Response to Anonymous Referee #1 – RC3

In "Mobile measurement of methane emissions from natural gas developments in Northeastern British Columbia, Canada", Atherton et al. describe with lucidity and apply with care an improved mobile survey technique for identifying methane leaks in an understudied region of Canada's oil and gas fields. The measurements are used to probe which aspects of the oil and gas infrastructure in the portion of the Montney region surveyed are most likely to emit methane. A conservative estimate of the bottom up inventory for entire Montney development is calculated and compared against state-based estimates, which is the most uncertain part of the analysis. The manuscript clearly describes the measurement and analysis techniques, highlights the limitations of the approach, and contextualizes the results nicely. I recommend this manuscript for publication in Atmospheric Chemistry and Physics with only minor changes.

“Figure 2: Mean distance from infrastructure while surveying each of the six routes listed in Figure 1. One standard deviation from the mean shows the range of distances at which we were sampling downwind of infrastructure.”

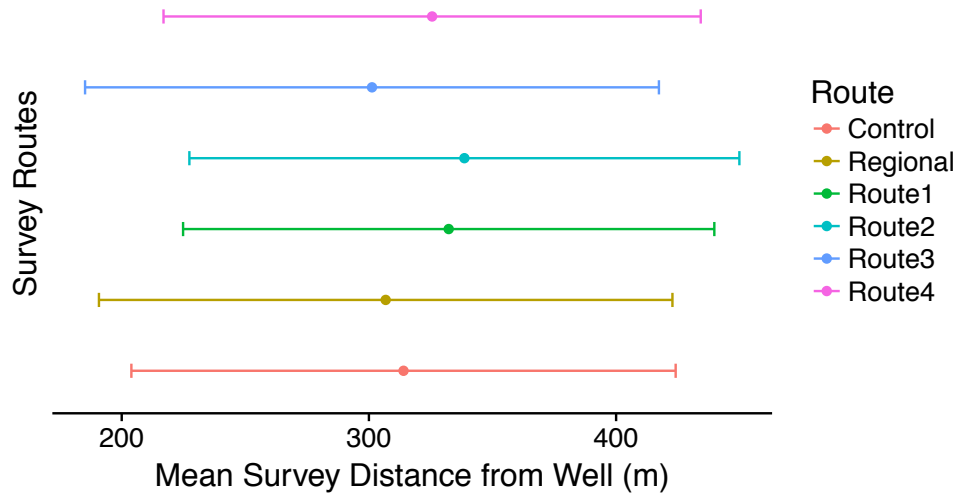
Figure 2 - If I understood correctly, industrial sources were passed on multiple routes. Could these dots and bars be color-coded (with colors from Figure 1) by the route on which the source was observed?

For clarity we have re-created this graph to show detection distances on each route. Below is the revised graph and caption.

“Figure 2: Example of a regression plot that demonstrates the optimization process we used to calculate an RMRI for each survey. The RMRI for each survey was chosen where the two linear regression lines intersect.”

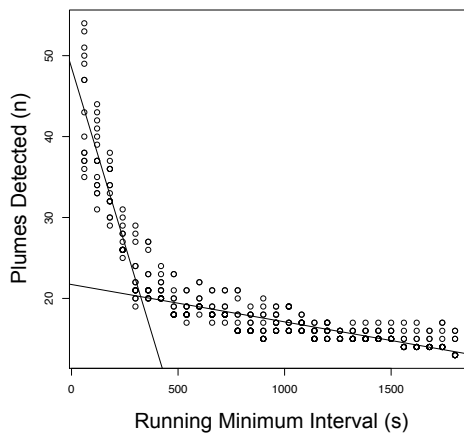
- P5 L10-12: "Our optimal RMRI was taken to be the point at which anomalies were maximized, but also where we avoided the rapid noise-associated increase associated with extremely short RMRI's": in practice, how was this optimization performed? It appears to be a subjective choice. Is this true? It would be preferable if the choice was made objectively using quantitative criteria; it would also be preferable to have the same algorithm be used for all surveys.

We did not choose the RMRI value for each survey subjectively. The optimization was performed with an algorithm that was applied to all surveys individually. We have added the following figure and associated text to the paper to clarify the quantitative process we used to determine the RMRI for each survey. Please see the figure, caption, and revised text below.

“Figure 6: Emission frequencies for each well mode type for all surveyed infrastructure on each route. These emission frequencies were considered in our total emissions inventory calculations.”

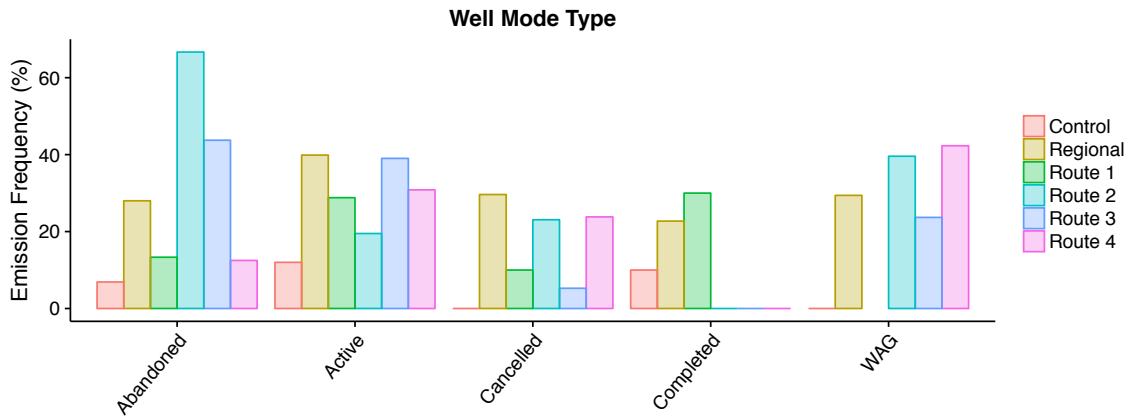
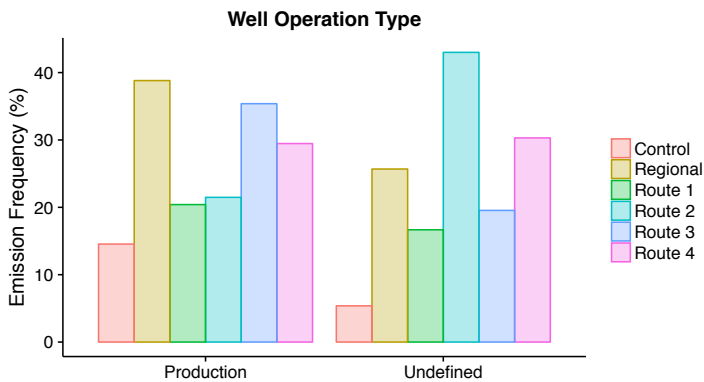
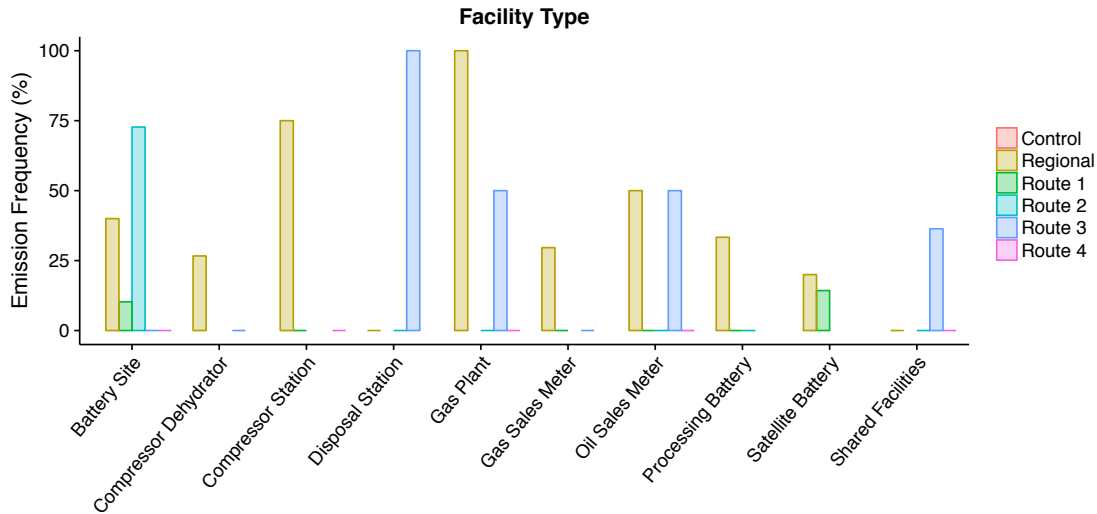
Fig 5: In some panels (e.g., the top panels), the regression lines do not pass through zero. This doesn't make any physical sense. Why should there be a threshold for number of wells surveyed below which no emissions should occur? Why would there be no emissions for surveys with fewer than 60 wells surveyed? I don't understand the rationale for a linear regression. Why not simply ratio the total number of sites with emissions / total number of sites surveyed across all surveys for each category? This would make more intuitive sense. Alternatively, the linear regressions could be forced through zero, which would be similar.

Fig 6 and 7: similar comments to above for Fig. 5.

We agree and have changed the linear regression plots to bar graphs which show the percentage of infrastructure emitting for each source-type. Please see the graphs and captions below. We have also made minor changes to the manuscript text accordingly.
